February 27, 2012

**Subject: Village Marketplace #912 Traffic Impact Analysis (ECN/CRN 10075 VUP 2010-044)  
Response to Comments**

CITY OF LA QUINTA COMMENT LETTER, DATED NOVEMBER 10, 2010

*CONSTRAINTS* EXHIBIT 1-C  
**CIRCULATION RECOMMENDATIONS**

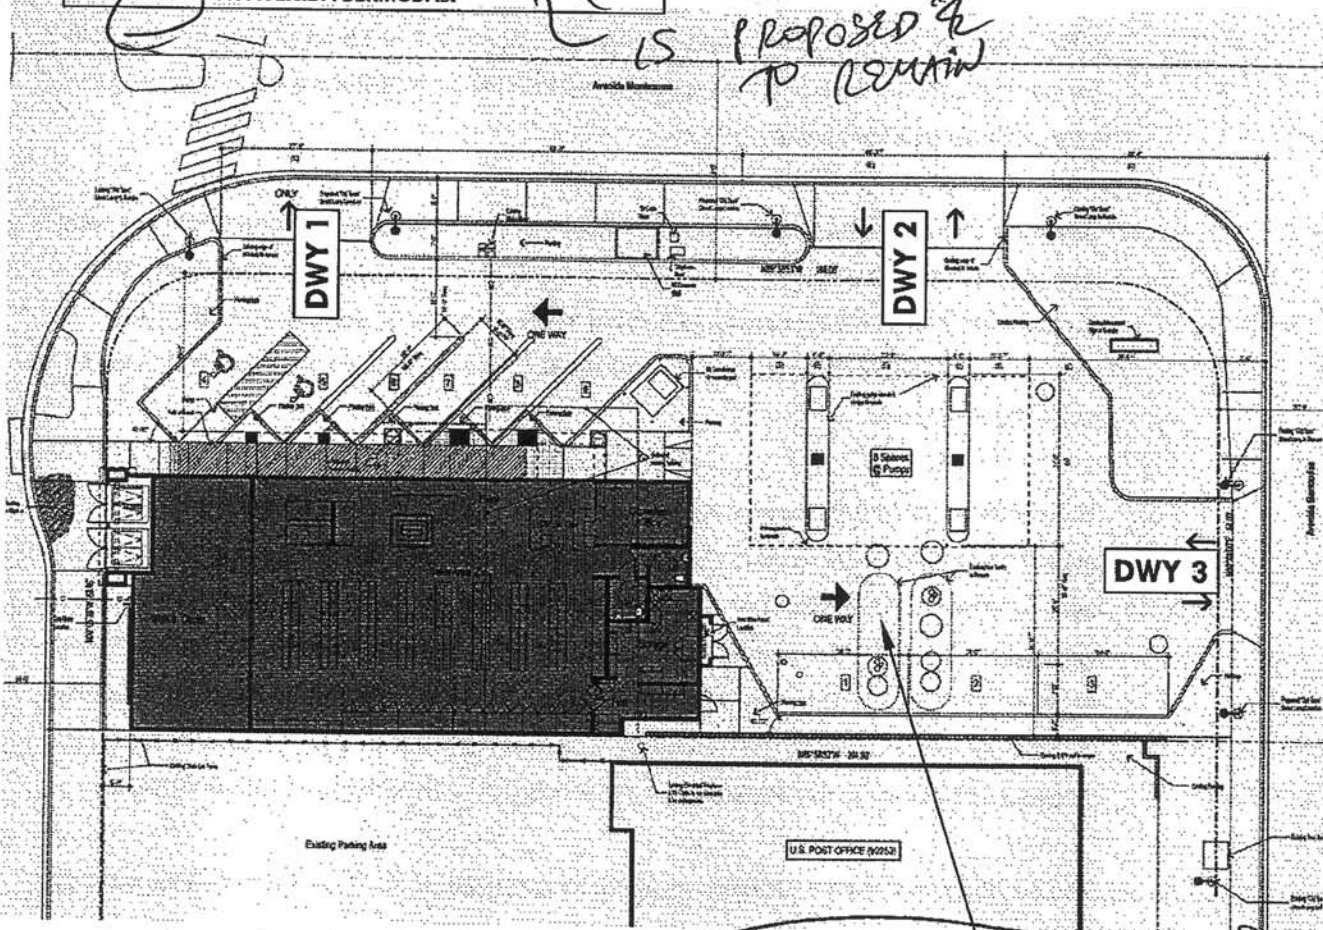
1.0 Executive Summary; Section E: Please see the attachment. Is Exhibit C the site plan comments? If it is, Urban Crossroads should address the fact that the driveway onto Avenida Bermudas needs to be either one-way or widened to 35 feet. I am assuming that the attachment covers all of the other concerns expressed by David Sawyer.

The site plan analysis is unacceptable as it still recommends a one-way access drive exiting the property by way of a two-way (ingress and egress driveway), as shown on page 6.

*THE APPLICANT WANTS TO PROPOSE*

As shown on Exhibits 1-C (page 7) and 7-A (page 93), the revised site plan included as part of this TIA shows a 35-foot driveway on Avenida Bermudas and assumes full access.

As shown on Exhibits 1-C (page 7) and 7-A (page 93), the revised site plan included as part of this TIA shows a 35-foot driveway (the City's minimum driveway width required for full access) on Avenida Bermudas and assumes full access in the analysis.
